Date March 2014
Subject Watermark Coal Project – Independent traffic review

The NSW Department of Planning and Infrastructure (DoPI) engaged Sinclair Knight Merz (SKM) in February 2014 to undertake a review of the traffic impact assessment of the proposed Watermark Coal Project and consideration of the need to upgrade local and regional roads as a result of the construction and operation of the project.

- Werris Creek Road / Bulunbulun Road (design speed < 100 km/h)

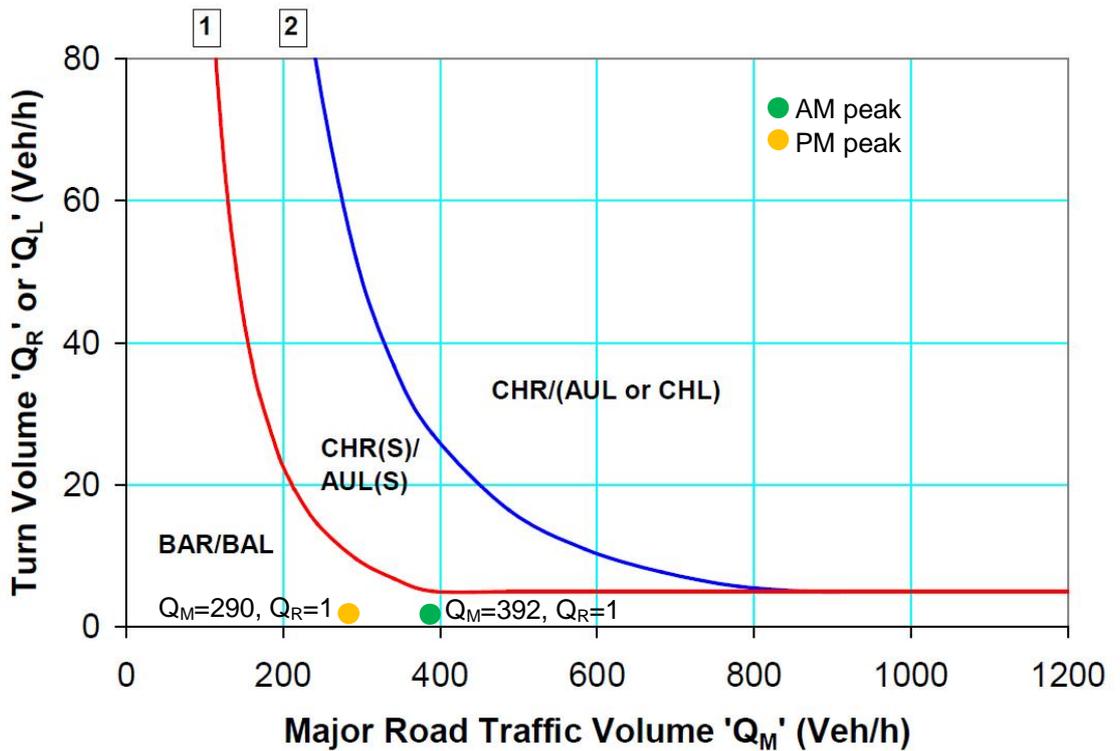
Based on this analysis, the Werris Creek Road / Bulunbulun Road intersection should be upgraded to a CHR(S) (channelised right-turn with a short turn bay). Given that the addition of Project-related traffic triggers the warrant for an upgrade of the intersection to a CHR(S), SKM considers the applicant responsible for the upgrade.

- Kamilaroi Highway / Waverly Road (design speed ≥ 100 km/h)

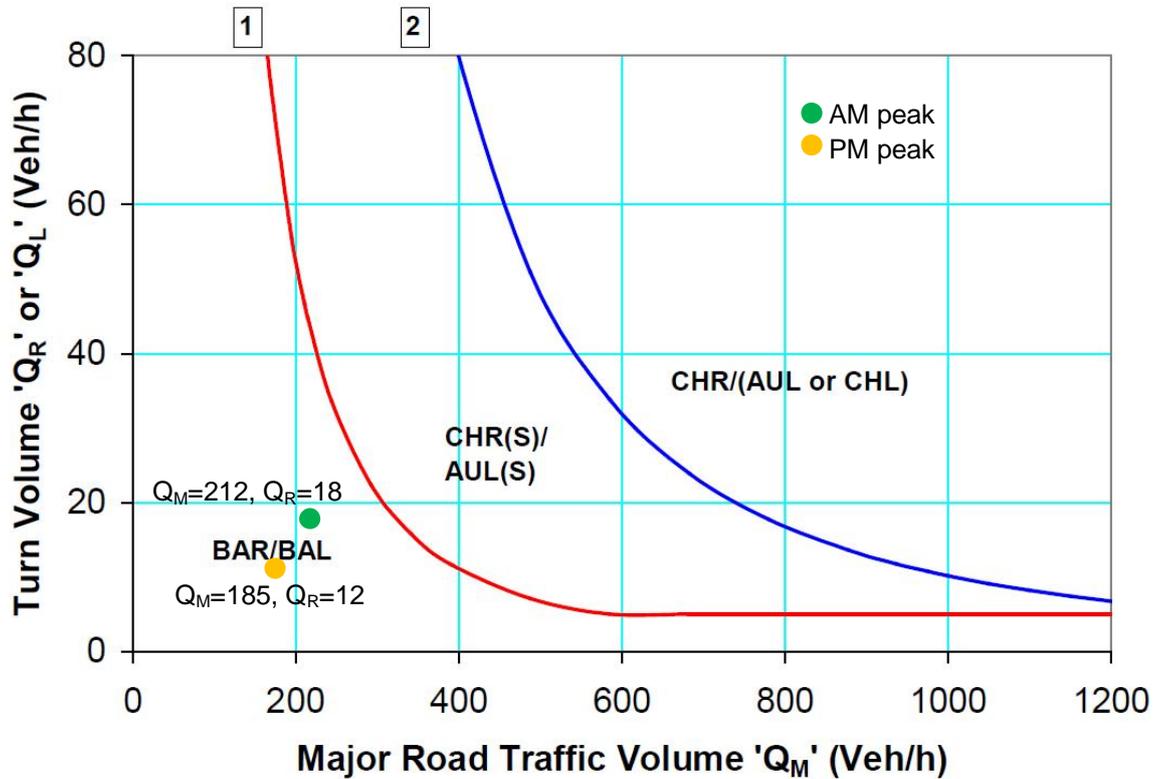
Road	Recommended upgrade	Reason	SKM consideration
Waverly Road	Upgrade intersection with Kamilaroi Hwy	Will be used by project-related with resultant road safety implications	Based on the analysis in (b), SKM considers that the recommended intersection upgrade is not warranted.
